LOGAN CITY COUNCIL

APPROVED PLAN OF DEVELOPMENT

MCUI/43/2016/B

DISTILLERY ROAD
124 DISTILLERY ROAD, BEENLEIGH
CLIENT - TONKEN PROPERTY GROUP

Title
**EROSION AND
SEDIMENT CONTROL
PLAN 1 OF 2**

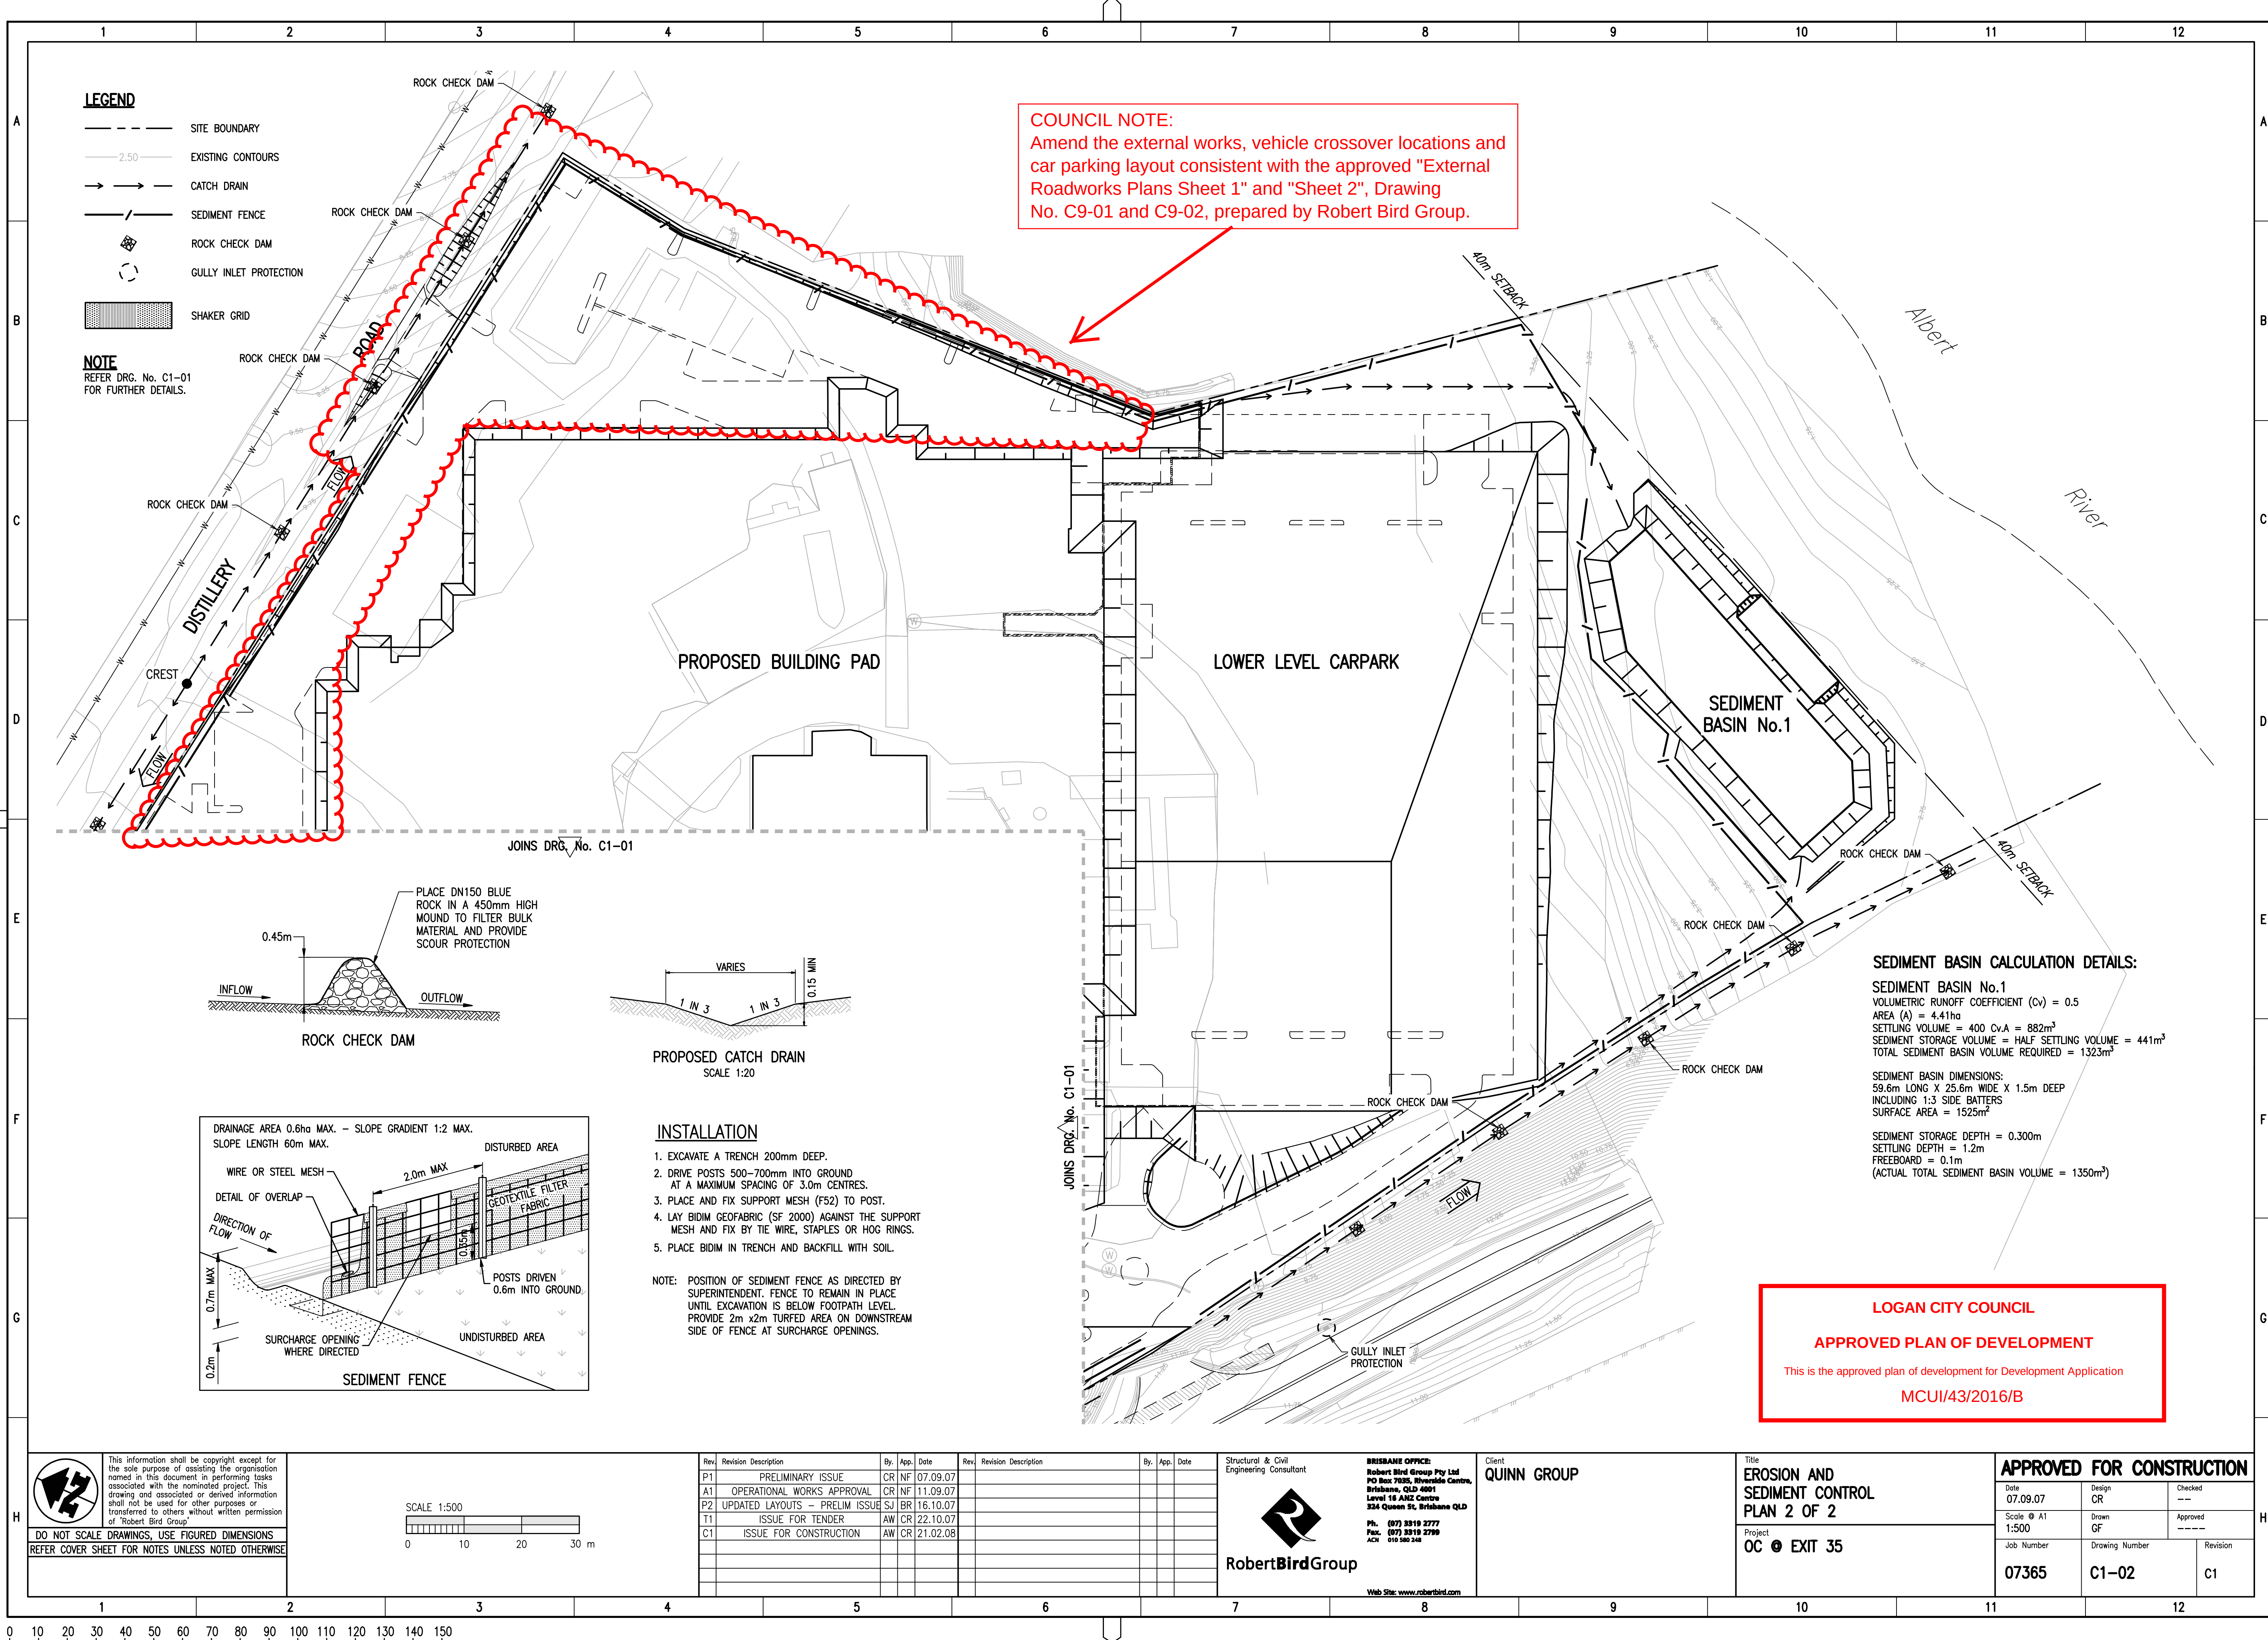
COUNCIL NOTE:
Amend the external works, vehicle crossover locations and car parking layout consistent with the approved "External Roadworks Plans Sheet 1" and "Sheet 2", Drawing No. C9-01 and C9-02, prepared by Robert Bird Group.

Title
**PAVEMENT LAYOUT PLAN
SHEET 1 OF 2**

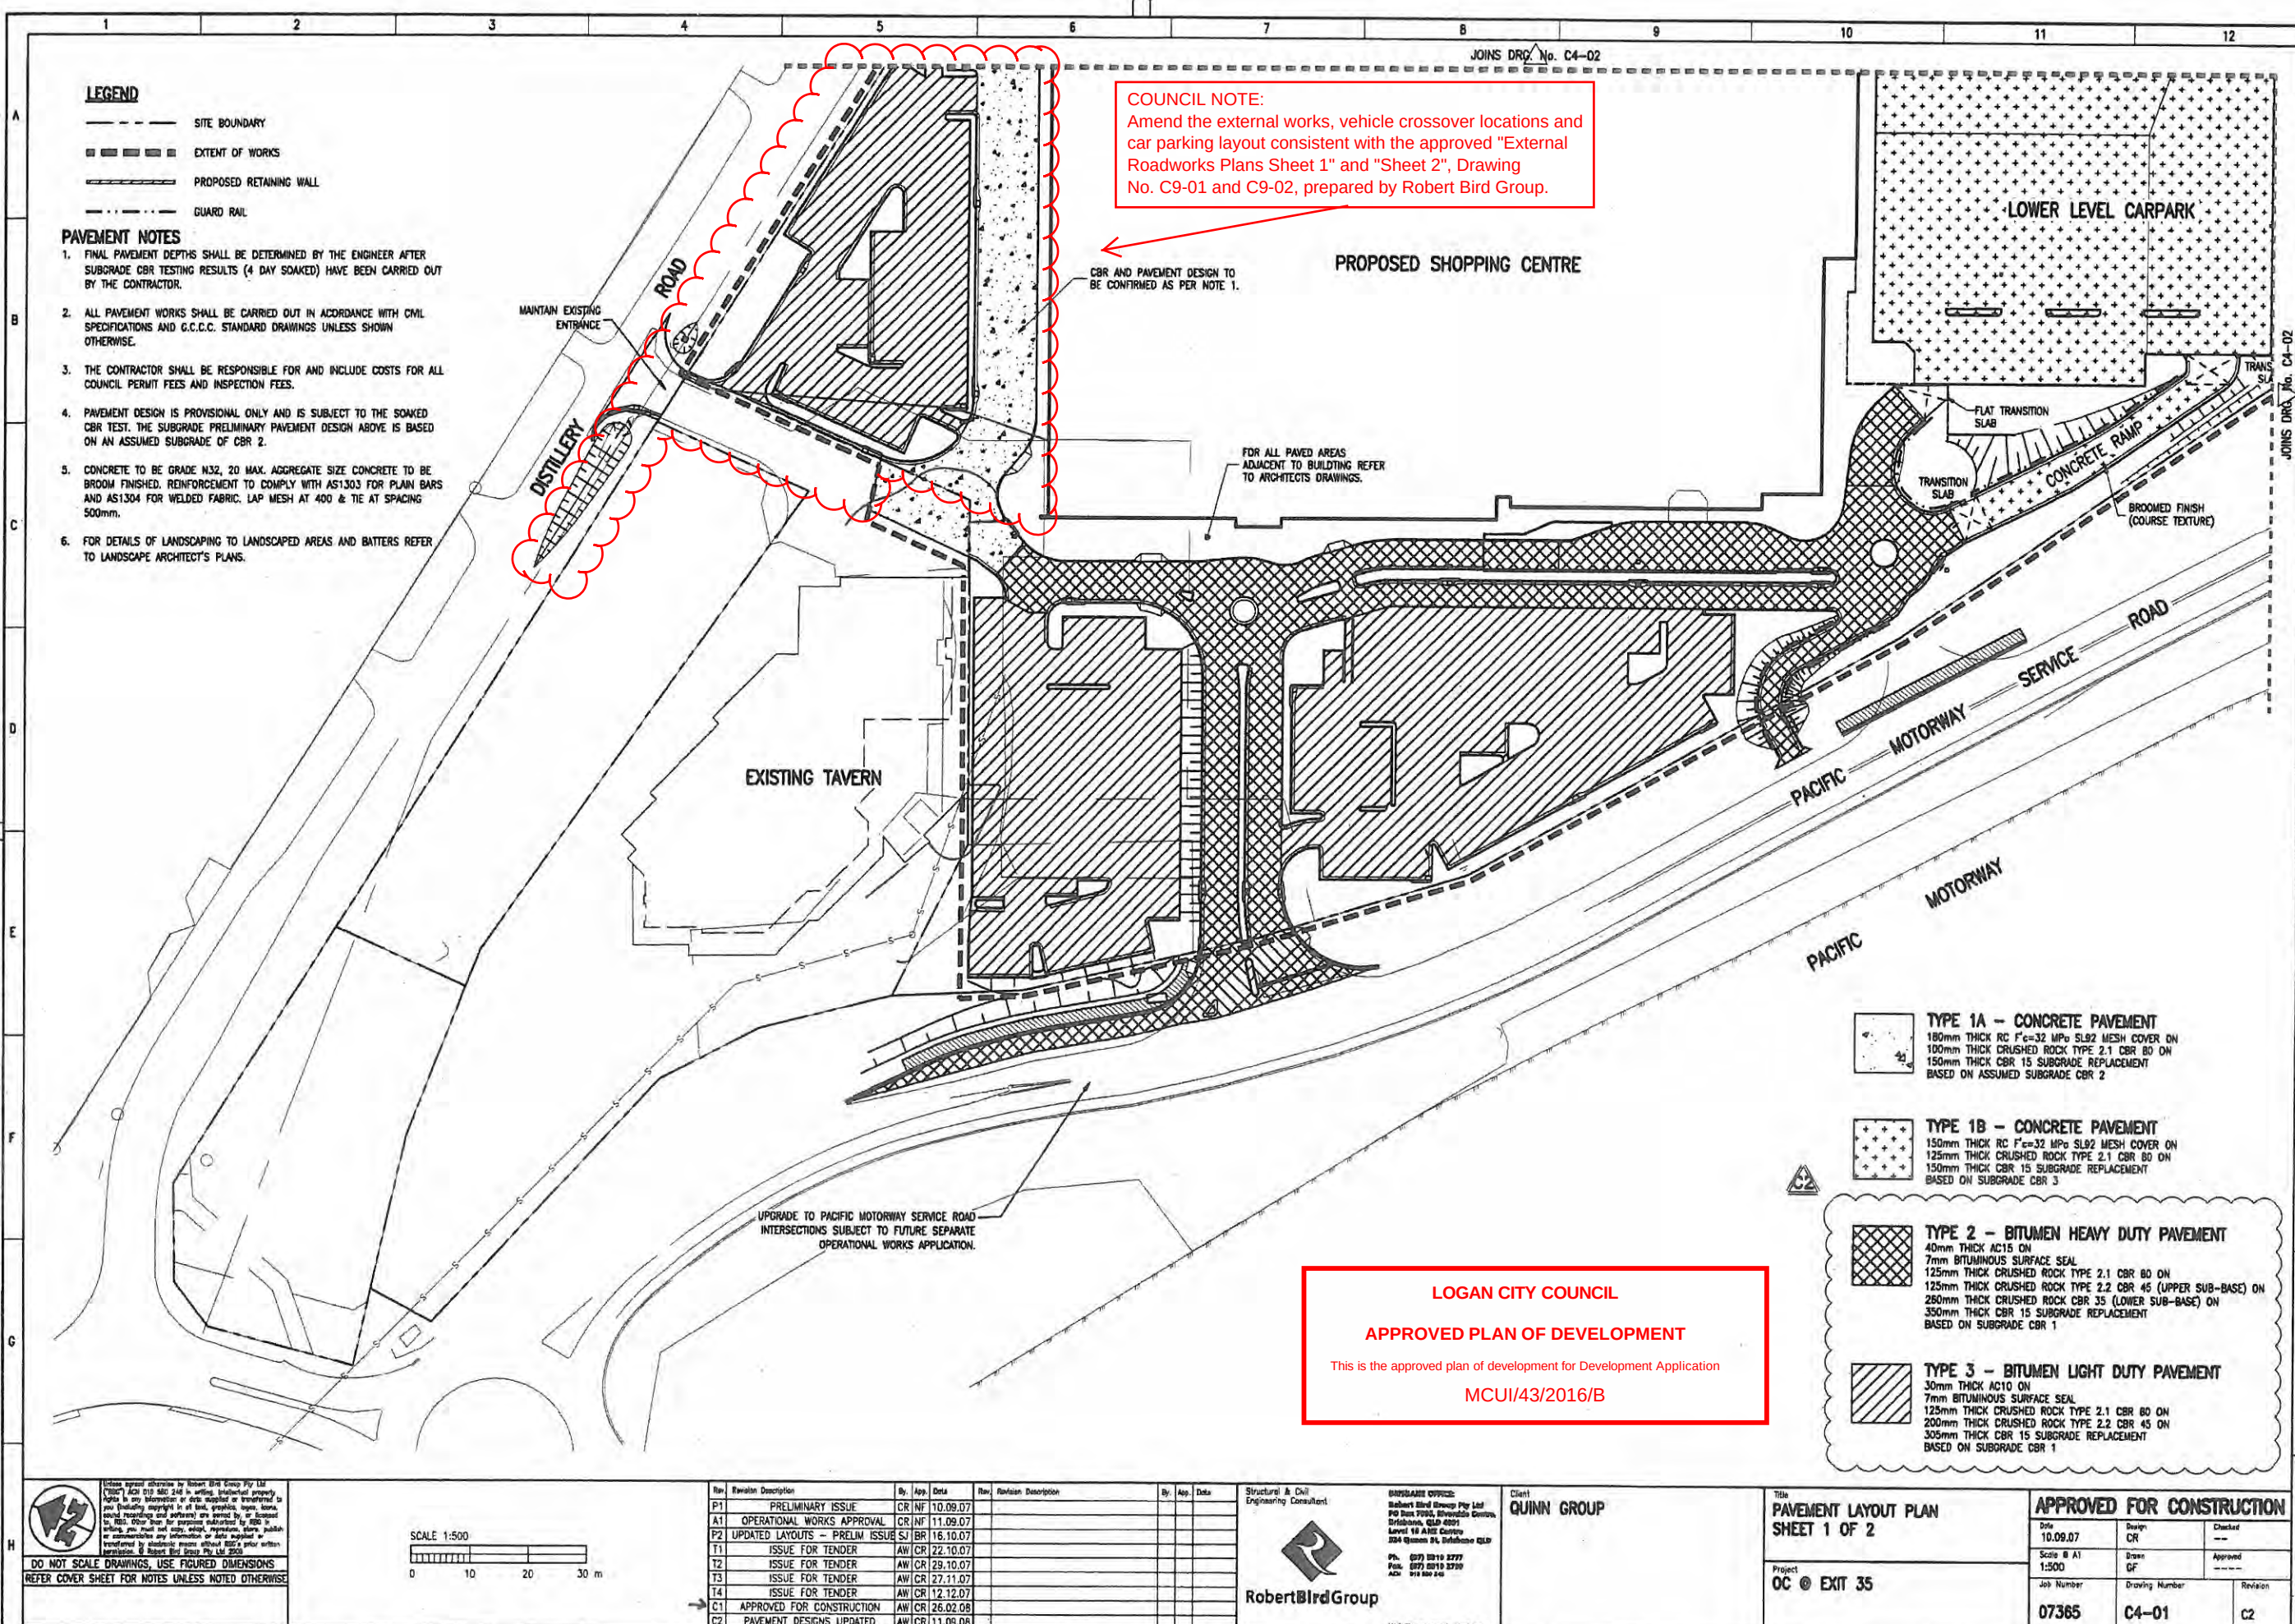
COUNCIL NOTE:
Amend the external works, vehicle crossover locations and car parking layout consistent with the approved "External Roadworks Plans Sheet 1" and "Sheet 2", Drawing No. C9-01 and C9-02, prepared by Robert Bird Group.

Title
STORMWATER DRAINAGE
LAYOUT PLAN SHEET 1 OF 5

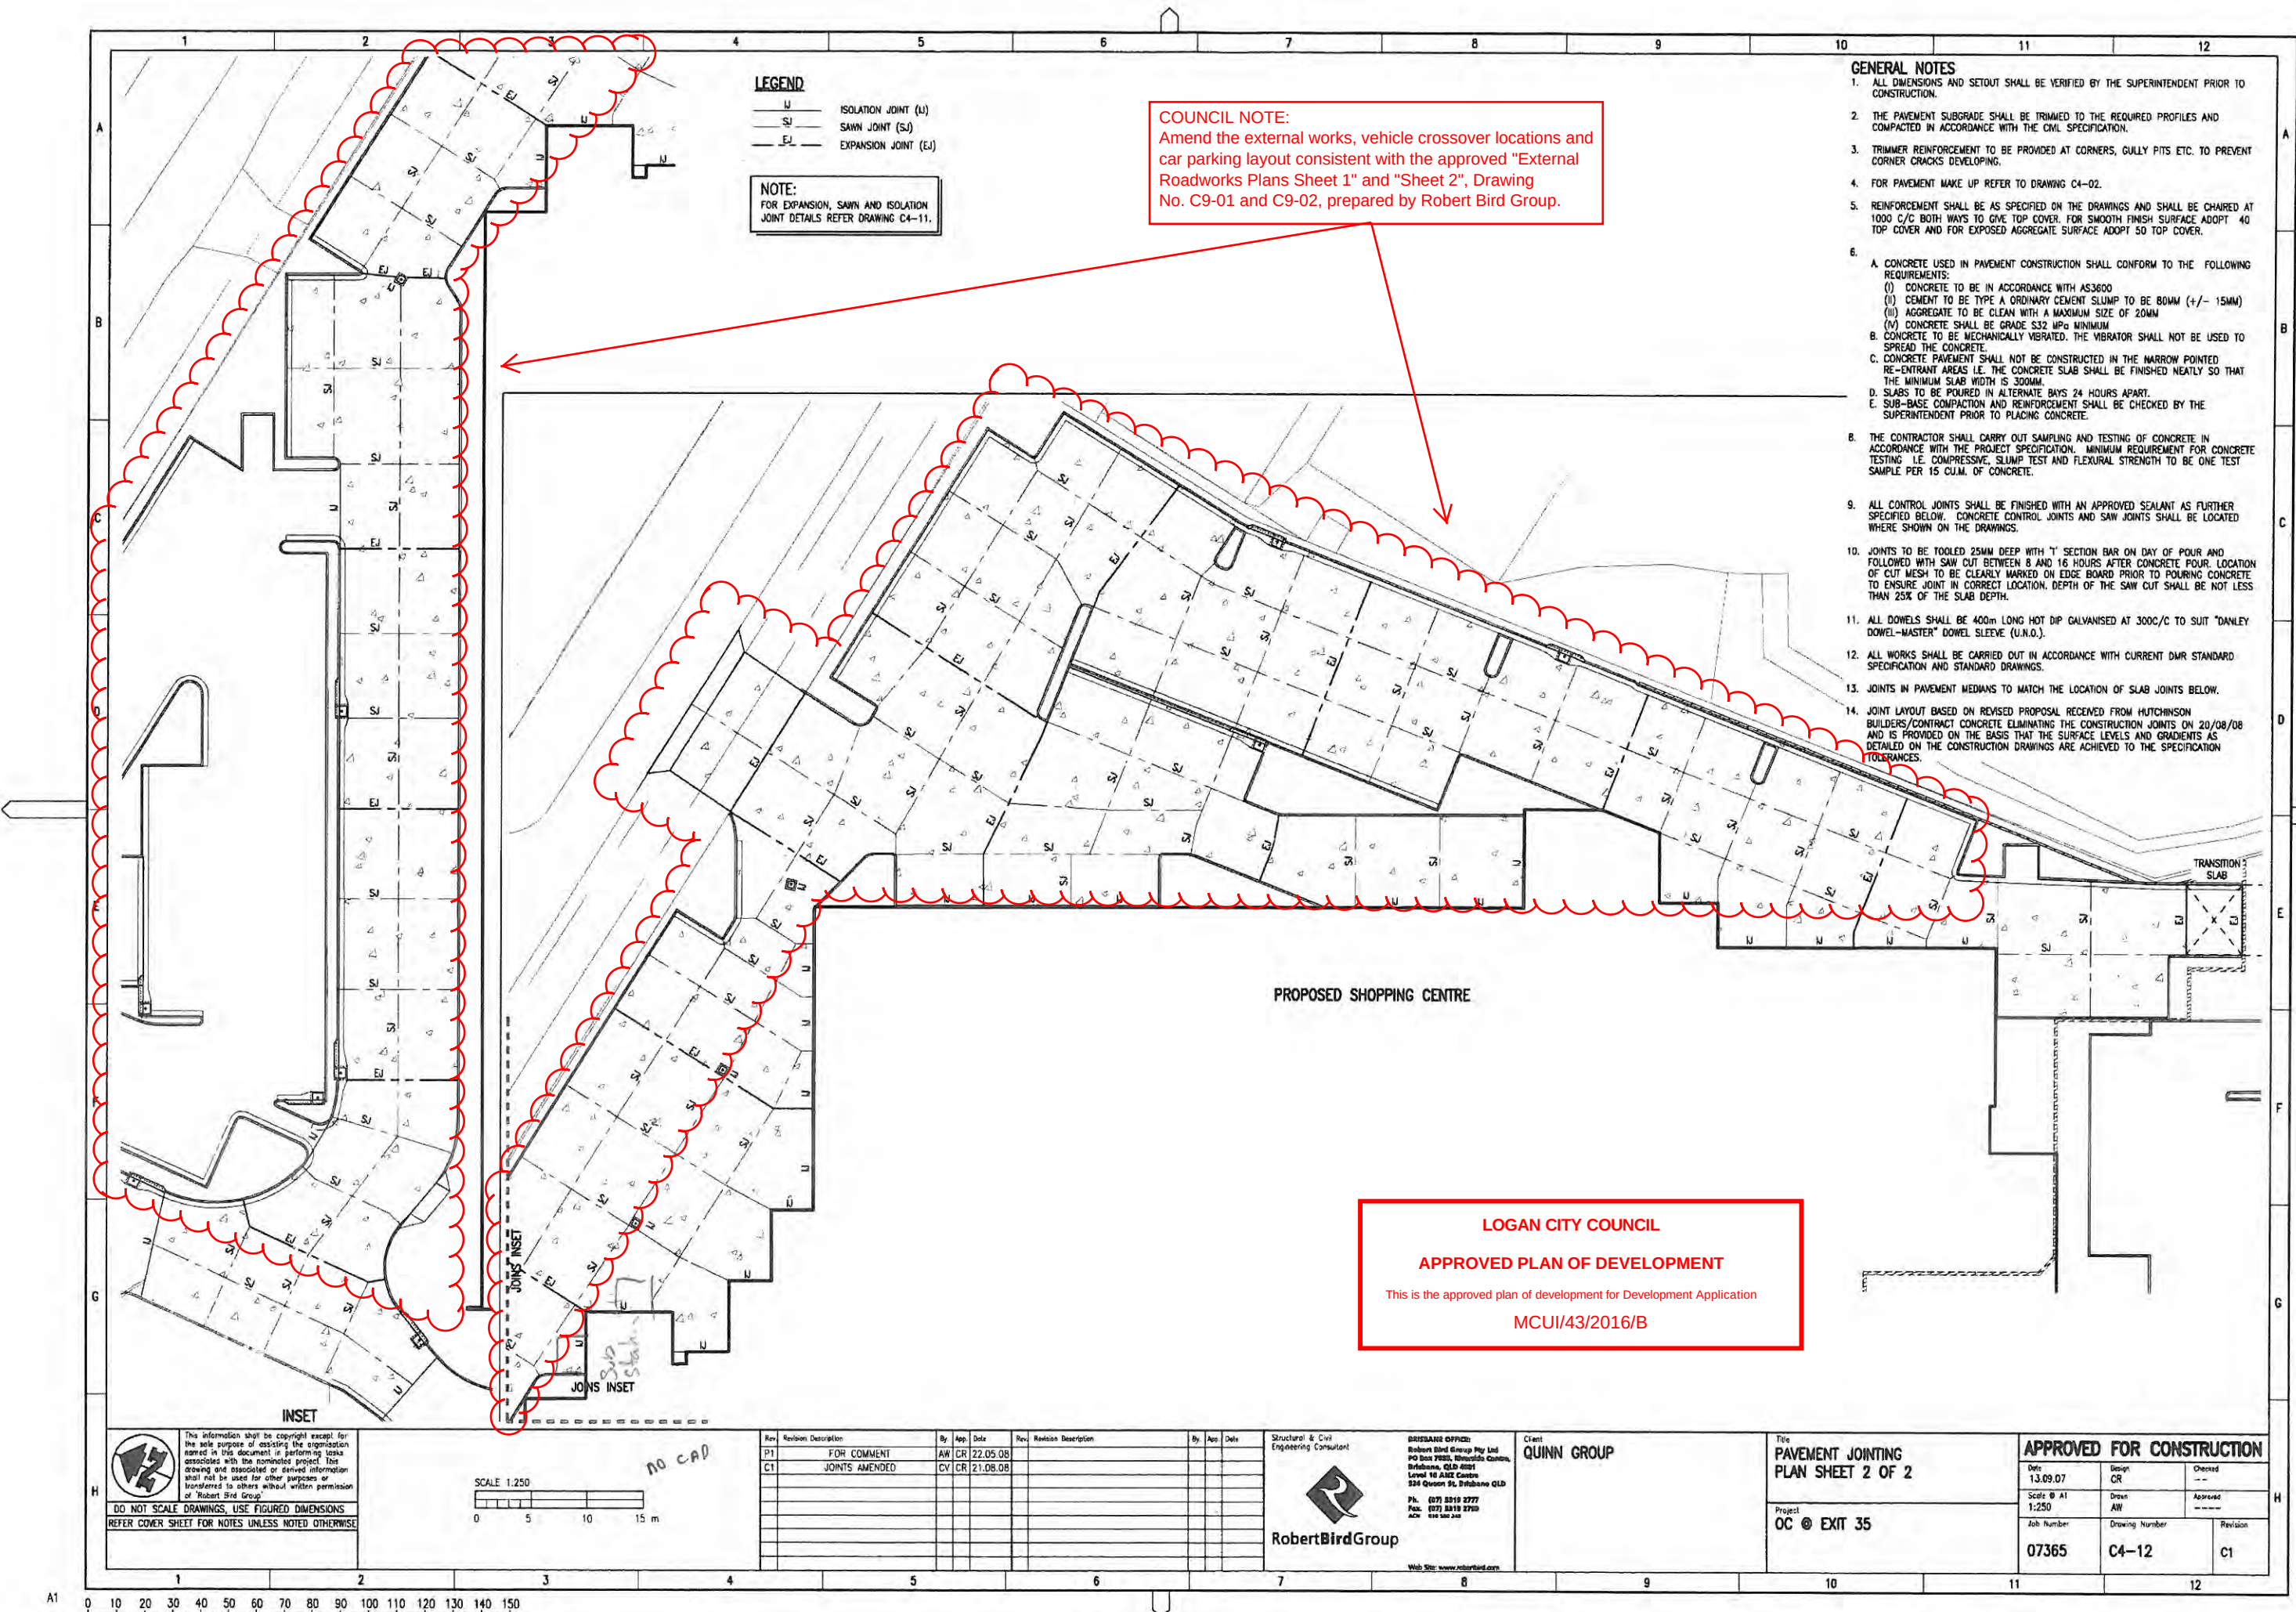
COUNCIL NOTE:
Amend the external works, vehicle crossover locations and car parking layout consistent with the approved "External Roadworks Plans Sheet 1" and "Sheet 2", Drawing No. C9-01 and C9-02, prepared by Robert Bird Group.
